Matching Hub Info

M1000 Semitrailer Tire

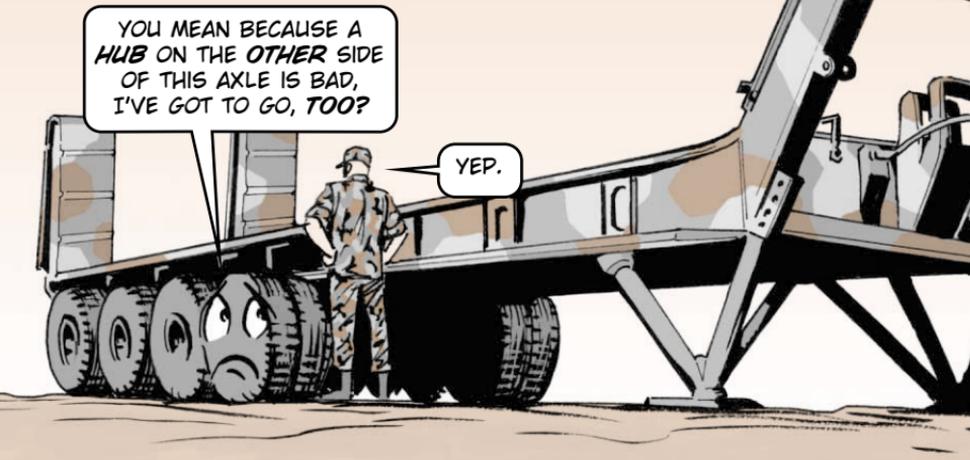
Mechanics, hubs for early model M747 semitrailers (serial numbers 1-200) are no longer available.

If a hub goes bad, you have to order two complete new hub and wheel assemblies—one for each side of the axle.

You can't run the old wheel and hub assembly on the same axle with the new one. They are not the same size. But you can run both types on the same trailer.

The new hub is the B type used on M747s serial numbered 201 and higher.

**OTHER PARTS—
BEARINGS,
SEALS AND
BRAKE PARTS—
ARE THE SAME
FOR BOTH
WHEEL DRUMS.**

ITEM	QTY per axle	NSN
Hub	2	3040-00-351-2581
Brake drum	2	2530-00-319-5720
Wheel stud	20	5306-01-014-7481
Lug nut	20	5310-00-538-0800
Wheel Assembly	4	2530-00-355-7763
